NUMBER: 84-8

- A. 1984 Model 18XD and 25XD Equipped with Tiller Handle Harness and Start Button Assembly, 87-95810A2
- B. Tiller Handle Inspection/Rework - Models 35/40/50
- C. New Service Tools Available
- D. Torquing of V-6 Cylinder Head Bolts
- E. Timing Pickup Change - V-200 S/N 6537933 and Above

Figure 2.

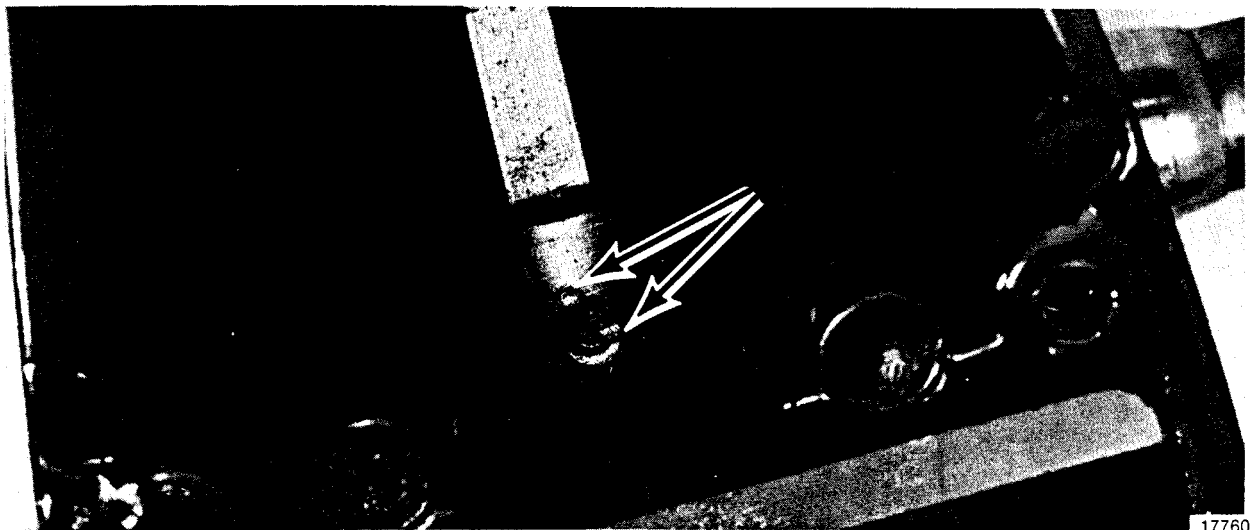
Inspect the retaining pin on the drive wheel and rod assembly. (Figure 2) The metal around the pin must be staked such that there is metal over the pin to retain it as shown in Figure 2. If the pin has not been properly staked (so as to retain the pin) use a chisel or center punch to stake pin.

Figure 3.

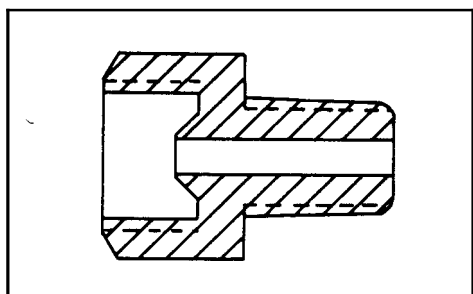
22-11243 Connector, Figure 3, used to adapt Power Trim Test Gauge, 91-52915A3 for checking pressure in the 1984 Model 75/90/115 Power Trim System. (Figure 4) 91-11230 Guide Tool - Lower Shaft, Figure 5. This tool is used as a guide to install the shaft into Power Trim manifold on 1984 Model 75/90/115 with Power Trim. (Figure 6)

Figure 7.

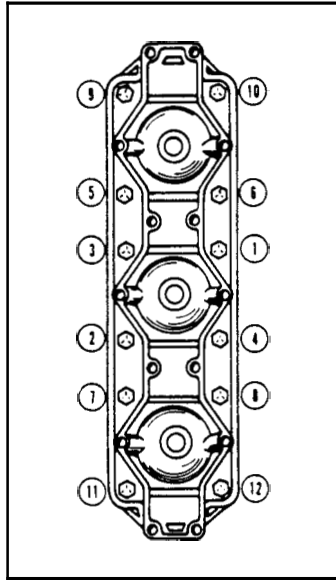
Mechanics are reminded that anytime they replace a short block assembly on a V-6 outboard, it is important that the head bolts be retorqued (as shown in Figure 7) after the engine has been run approximately 3 hours. The torque setting is 40 ft. lbs. (54.2 N.m.).
